Subject: Revision 5 to Application for Amendment 1 to TN-68 CoC 1027  
Docket 72-1027, TAC L23802

Transnuclear, Inc. herewith submits Revision 5 to its application for Amendment 1 to TN-68 CoC 72-1027. Based on recent discussions with the NRC staff, this revision makes changes Updated Final Safety Analysis Report chapters 4 and 9 to regarding TN-68 cask thermal view factors, and neutron absorber testing, respectively.

**List of Enclosed UFSAR pages**

Figure 4.10-2  
Finite Element Model for Radiosity Methodology

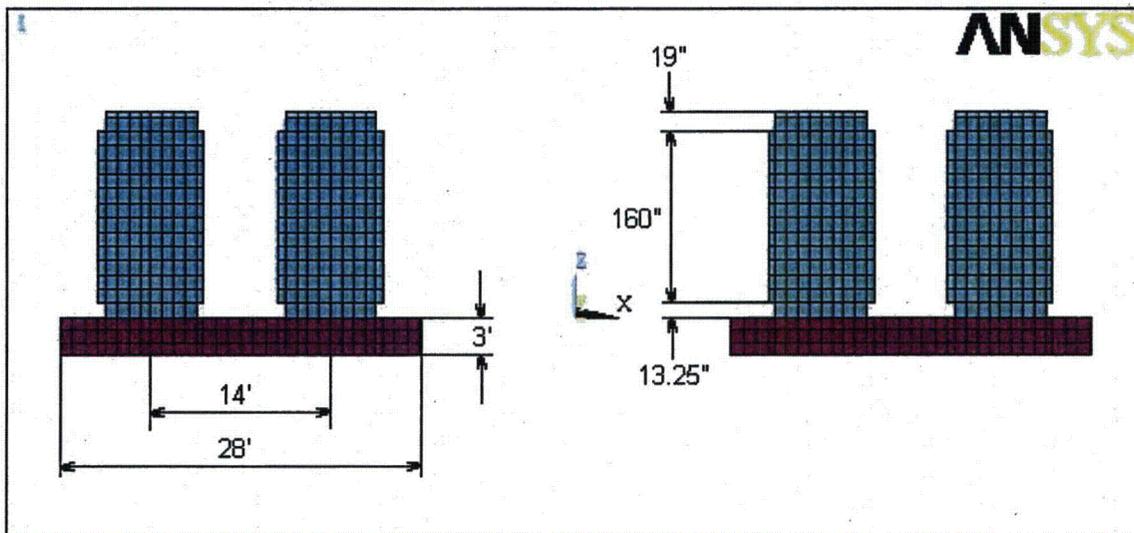
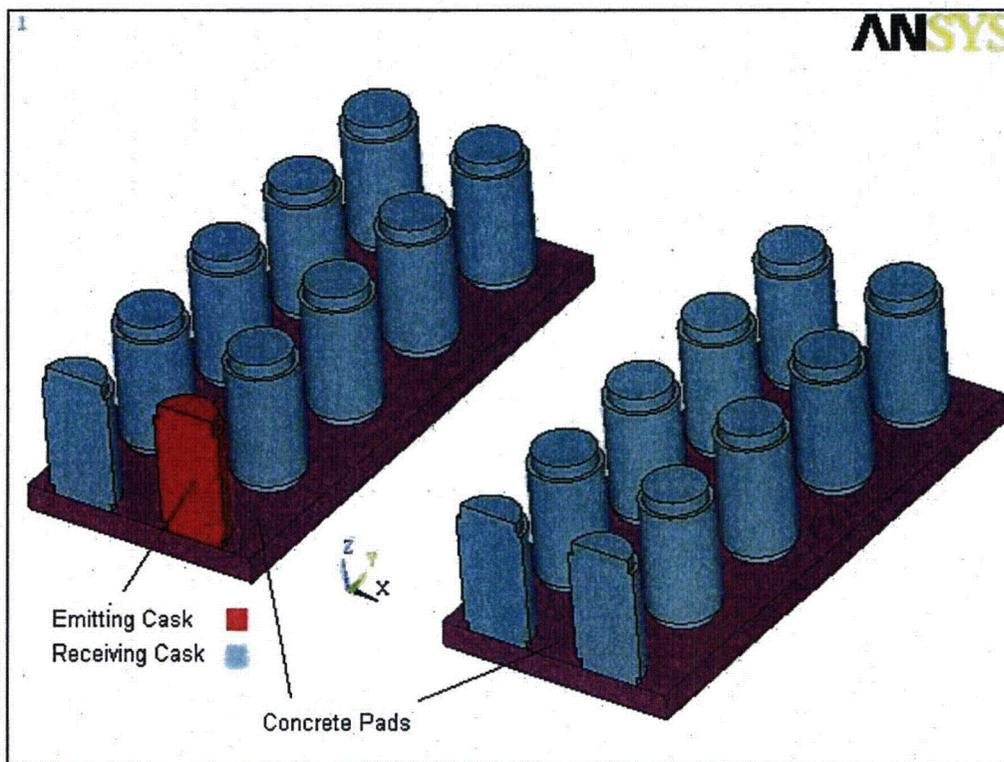
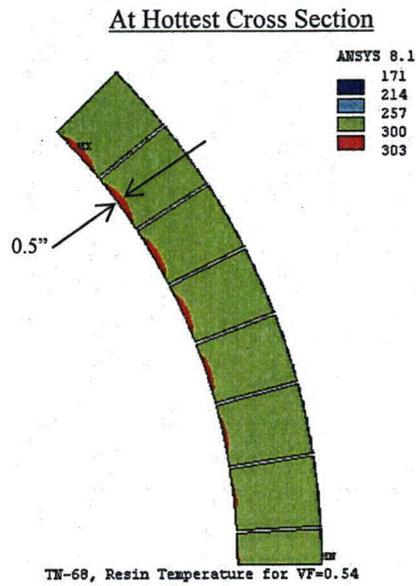
- Page annotated "Intentionally Blank" (back side of page 4.11-1)
- Figure 4.10-2, Rev 5, new figure referenced from new Section 4.10.1.1
- The back of Figure 4.10-2 is blank and not annotated, per the previous convention.

A finite element model of the two  $2 \times \infty$  storage arrays of TN-68 cask is created using ANSYS compute code [12]. This model considers half of the emitting cask and is extended to four complete casks stored in the two  $2 \times \infty$  storage arrays. This model is illustrated in Figure 4.10-2.

Figure 4.10-3  
Temperature Distribution of Radial Neutron Shield Resin for Case # 4

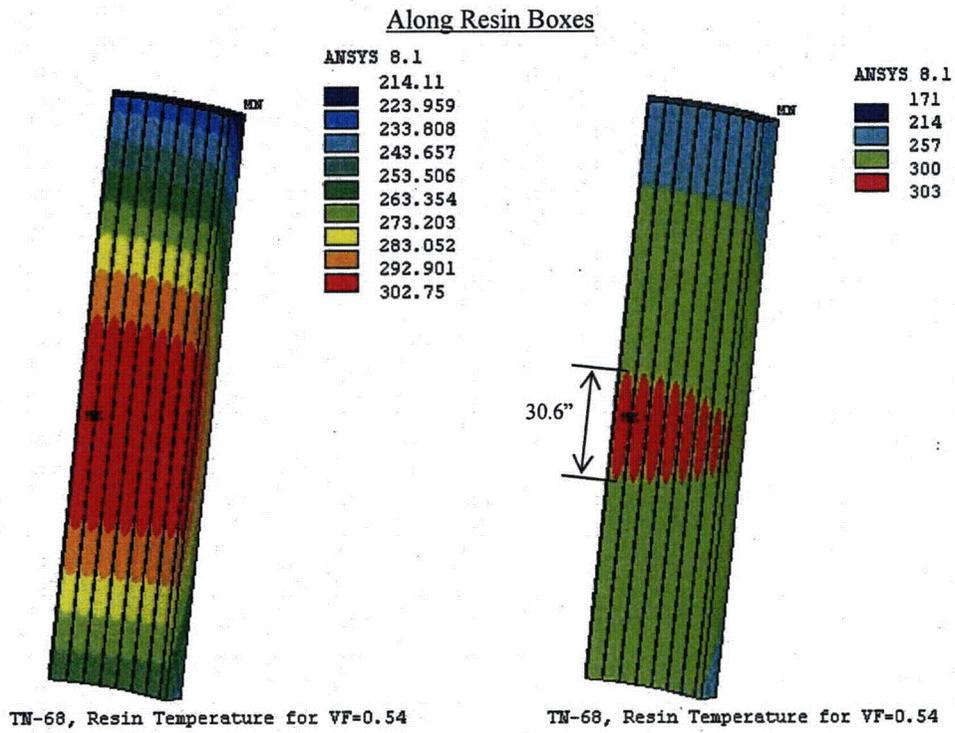
- Figure 4.10-3, Rev 5, new figure referenced from new Section 4.10.1.1
- The back of Figure 4.10-3 is blank and not annotated, per the previous convention.

As seen in Table 4.10-3, only the maximum temperature of the radial neutron shield (resin) exceeds the limit for the lowest view factor (case # 4). The average resin temperature at the hottest cross section is 287°F. This temperature is below the 300°F limit. Temperature distributions for the radial neutron shield are shown in Figure 4.10-3 for case # 4.
